# HISTORIC AND DESIGN REVIEW COMMISSION

January 16, 2019

**HDRC CASE NO:** 2019-006  
**ADDRESS:** 1539 W ROSEWOOD AVE  
**LEGAL DESCRIPTION:** NCB 2767 BLK 72 LOT 19  
**ZONING:** R-4  
**CITY COUNCIL DIST.:** 1  
**DISTRICT:** Keystone Park Historic District  
**APPLICANT:** Monica Alexander  
**OWNER:** Monica Alexander  
**TYPE OF WORK:** Porch modifications  
**APPLICATION RECEIVED:** January 03, 2019  
**60-DAY REVIEW:** March 04, 2019

The applicant is requesting a Certificate of Appropriateness for approval to replace existing concrete porch with wood decking and handrail.

FINAL "AS-BUILT" SURVEY

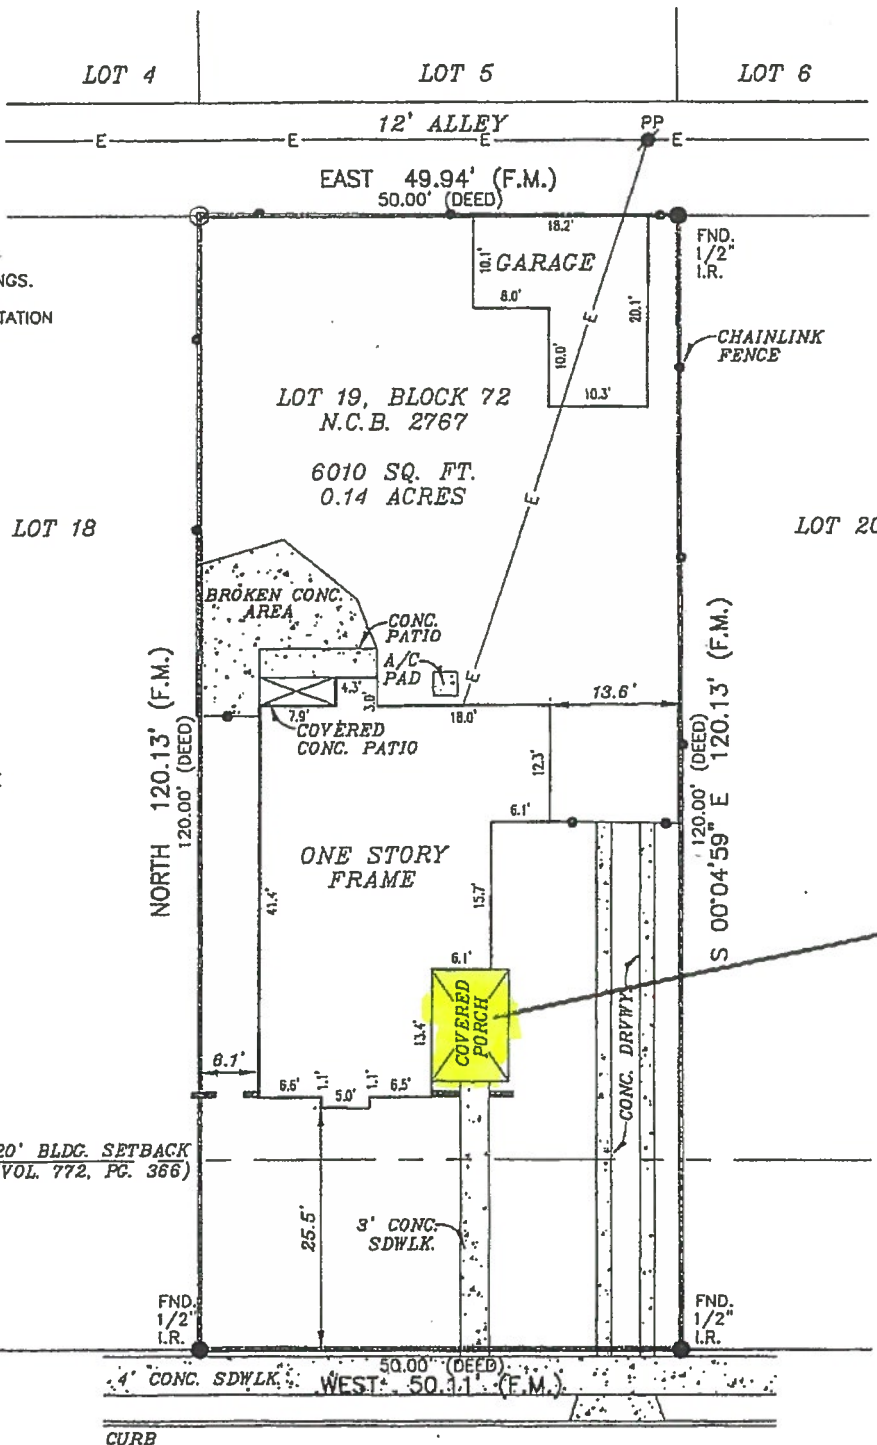
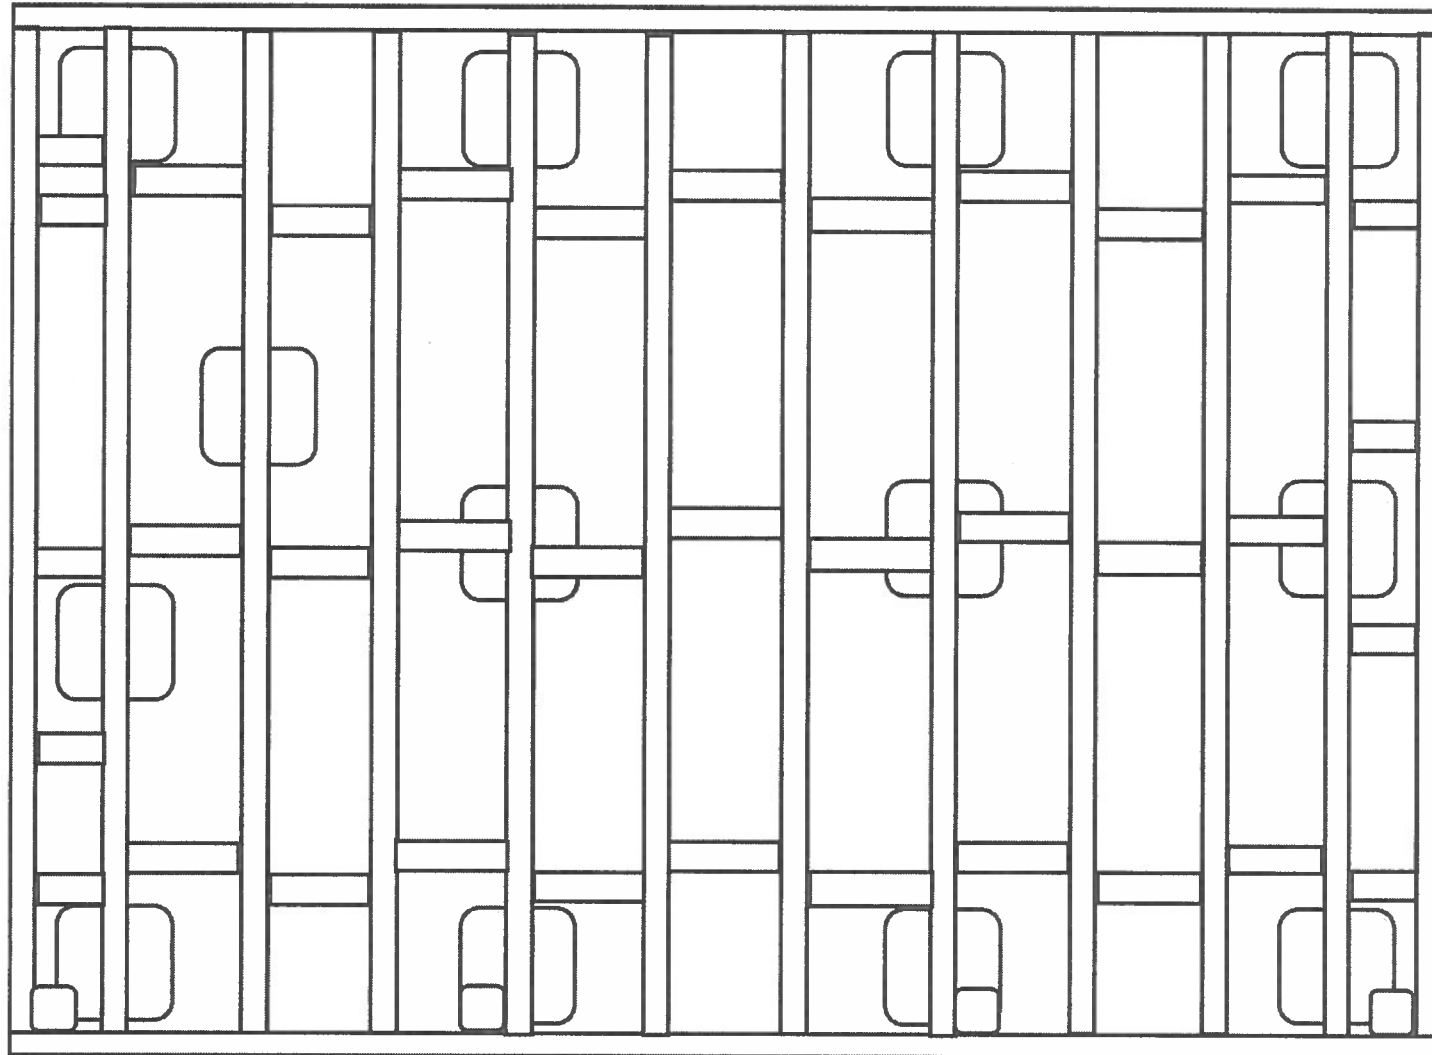
Current Area  
of concrete that  
draining under the  
house.  
① Demolish & remove  
② Replace with precast  
wood Deck as  
per drawing.

Deck Framing 2x6 or  
2x8 as height allows

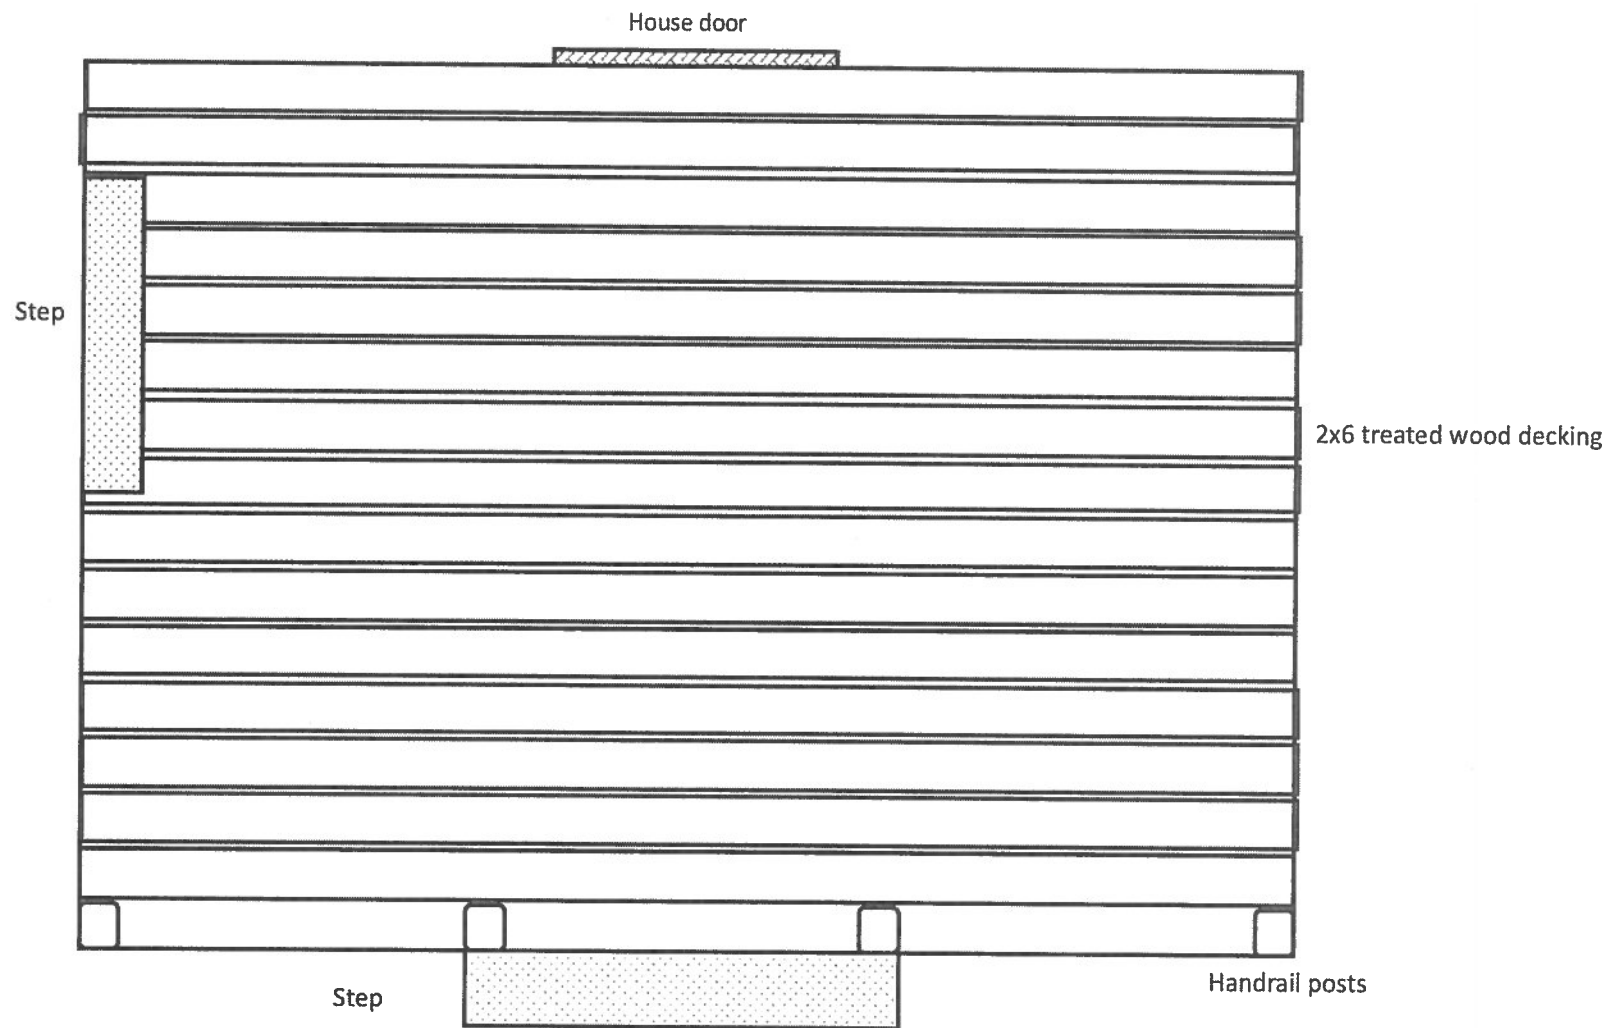
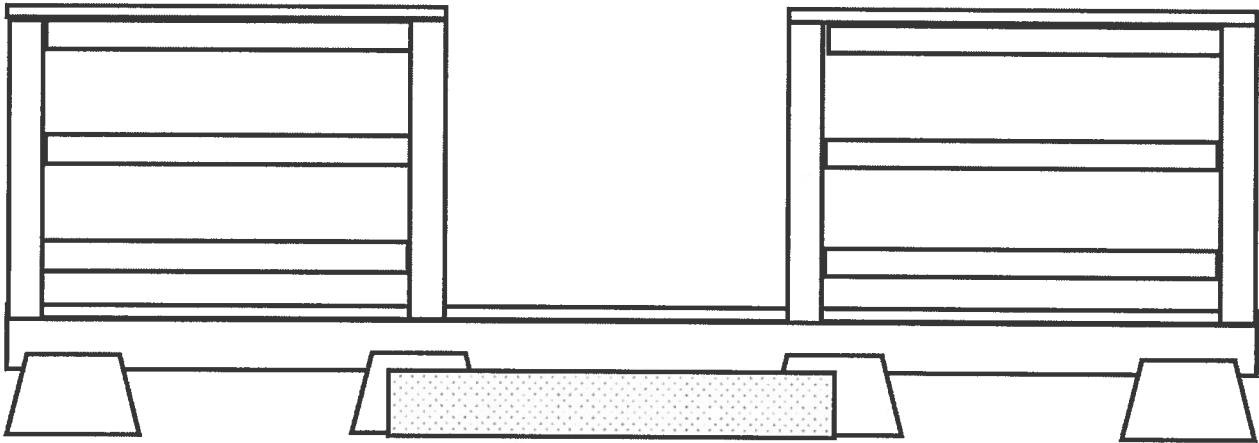
- b. **FRONT PORCH SLAB REPLACEMENT** – The applicant has proposed to remove the existing concrete front porch slab and install a new wooden deck, supported by new concrete piers, in the same location. According to the Historic Design Guidelines, original concrete porch floors should be preserved. However, the existing concrete front porch slab is not a significant character-defining feature and is not visible from the public right-of-way, as the porch is recessed and concealed behind the front façade. Therefore, staff finds the replacement acceptable given these property-specific considerations.

- c. **INSTALLATION OF HANDRAIL** – The applicant has proposed to install a new wood handrail at the porch entrance, inside the front façade. The handrail will not be visible from the public right-of-way. No modifications will be made to the front façade, including the gabled porch entryway, as part of this work. Staff finds that the proposed handrail will not detract from the significance of the structure.

Staff recommends approval of the porch modifications based on finding a through c.
